Westco

Burgess Park Southern Entrance Project: Results of the second public consultation

4.2. Play Area

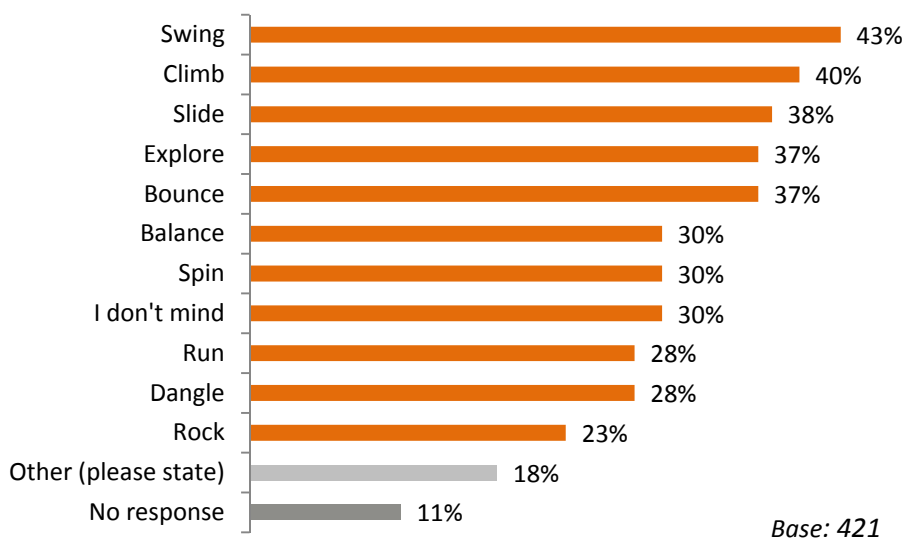
P171	Great to do up the Southern Entrance. Our only objection is to the location of the playground. Too close to the residents back walls on Add. Square.
O22	I am a local resident and am concerned about how close the new barbecue area is to local houses. Unfortunately people leave lots of mess after barbecues and this wont be nice so close to houses. I think the pond area would be a much nicer place for the barbecues. Not only for the reasons I have already stated but also I think it would just be a nicer area to have a barbecue, overlooking the pond. I'm also concerned about the noise from the playground. I notice that people's back gardens will back onto the playground and I think for those residents noise may be bothersome. However, overall I am excited about the new plans and especially happy about the new pond and plans to keep the underpass as it is.
P041	I am very concerned about the location of the proposed children's play area. It would be better located further into the park. It's proposed location would be noisy for local homes and potentially attract noisy drunks on the evenin. Please reconsider its location.

P044	I don't agree with the playground being right next to the houses. There are many other places better suited.
O57	I like that the aim is to remodel the Rust sq entrance to the park and to make it more visible and welcoming. The planned pond and increased biodiversity is also very welcome. The plans overall seem interesting and carefully thought through. I have 2 serious concerns though which are: 1. The position of the children's playarea, and 2, the proposed BBQ area. I very much support the idea of an additional children's play area but the current proposed position is abutting our garden wall and is very likely to be noisy both during the day, with playing children and also an night with anti social behaviour. There are many possible positions for an additional playground in the park where it can be well away from residents homes and therefore not cause a noise nuisance. Plse could you locate the play area further towards the proposed pond area or possibly near to the tennis courts. BBQs and noise Currently, and usually on warm nights, revellers gather in th park near the Rust sq entrance at different hours, and play loud amplified music and shout. This occurs sometimes starting at 5.30 am on a Sunday morning or late into the night. It would be helpful if there could be some signs up in the park reminding visitors that there should be no amplified music. Also that there should be no BBQs outside of the designated areas, and that the designated areas should be well away from homes. Thank you for taking care to consult re the plans and I look forward to a much improved park building on the excellent progress already achieved. The planting alongside the tennis courts is gorgeous and I always take a detour when popping to Walworth rd to look at the planting. Well done.

P168	Rust Square looks beautiful in the plans (not now!). Definitely needs some plants!! I am concerned that youth hangout areas are close to residential buildings. The play area is within earshot of my house - perhaps it could be a little further away?
P036	The siting of the barbecue and playground is very unfortunate. Why put Addington Square at the mercy of loud noise on holidays, nights and weekends.
FP004	There are too many noisy activities located very close to Addington Square. The playground is located under the planes trees which are old rolsop large branches. They also have TPOs on which prohibits anything that damages them. Is [the play area] for adults too - it was not mentioned.
FP003	To reduce noise and smell from BBQs all items should be further, say 200 metres, from the back garden walls of houses in Addington Square.

4.3. Nature Area

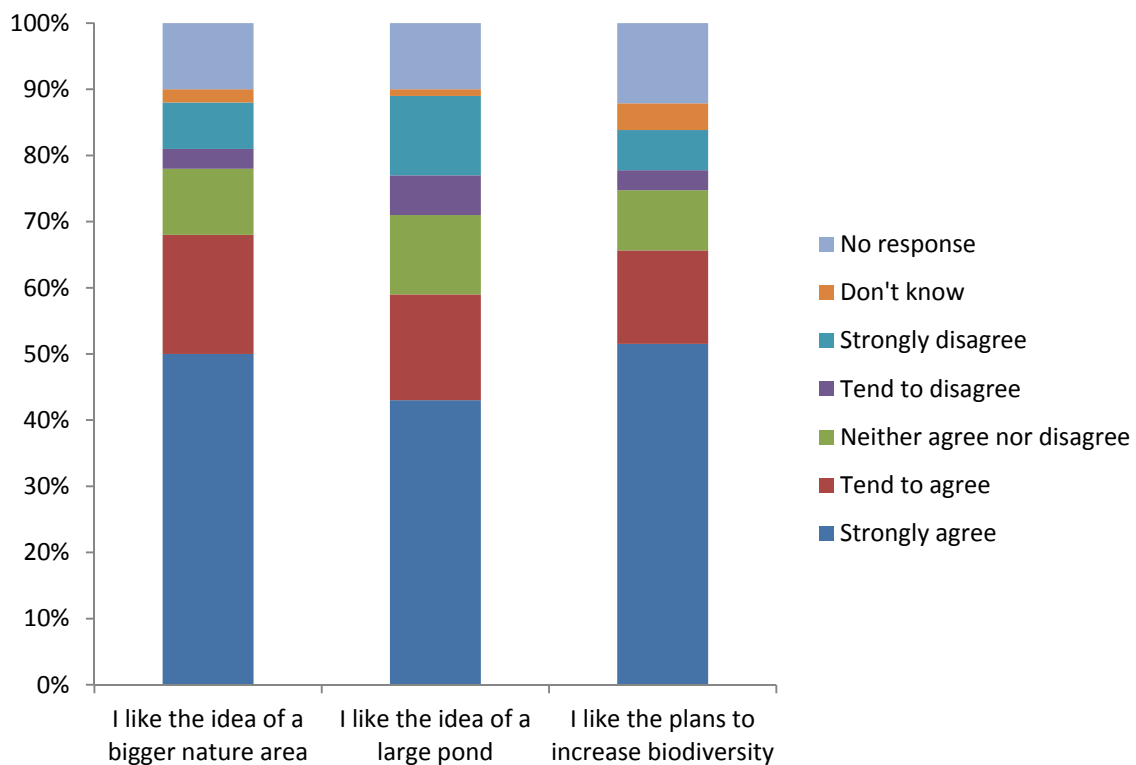
A minority of respondents did not like the idea of a bigger nature area or plans to increase biodiversity in the park (10%) although a higher proportion of respondents disagreed (*strongly disagree/tend to disagree*) with the idea (17%) of having a large pond in the park.
